WASHINGTON AREA BICYCLIST ASSOCIATION

Re: Comments on Alabama Avenue SE Corridor Safety Study

Alabama Ave Alt 2 Modified

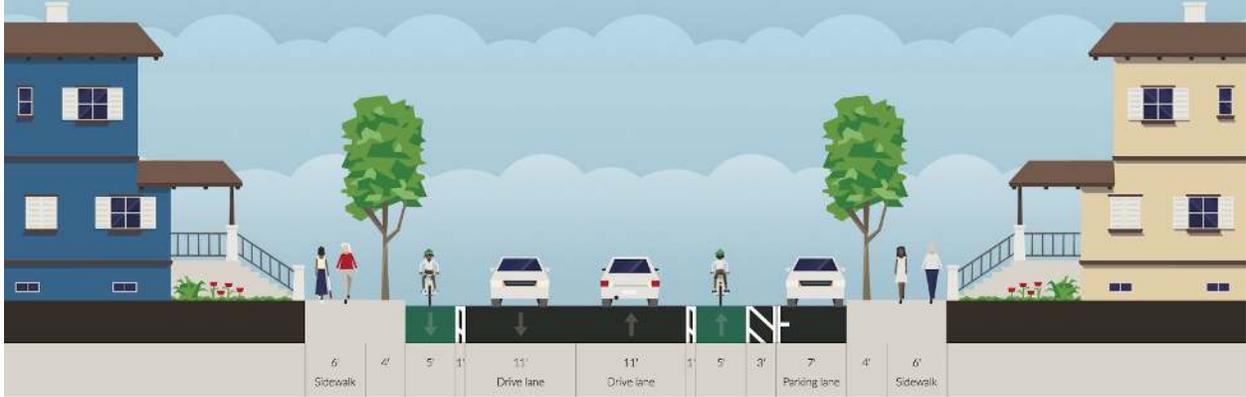
Compared to alternative 1, however, this design does less to protect people on bikes. In alternative 2, bicyclists are separated from moving cars by only a narrow 1 foot painted buffer, which puts bicyclists very close to the travel lane. As with the alternative 1 design, we suggest DDOT install vertical separators for the non-parking side of the road to prevent drivers from driving or parking in the bike lanes.

To better separate bicyclists from traffic on the parking side, we propose a different configuration that accomplishes the same goal of maintaining parking. With a full nine feet devoted to bike lane and buffer on the parking side, there is adequate space to place the bike lane between the curb and parking lane. This could accommodate a 6 foot wide bike lane, 3 foot buffer and full parking lane. Pedestrian refuge islands, similar to those found in New York City, could be added at crosswalks to shorten crossing distances, and floating bus stops could be added to eliminate the bus passenger / bicyclist conflict. Consult the NACTO Urban Street Design Guide for best practices.
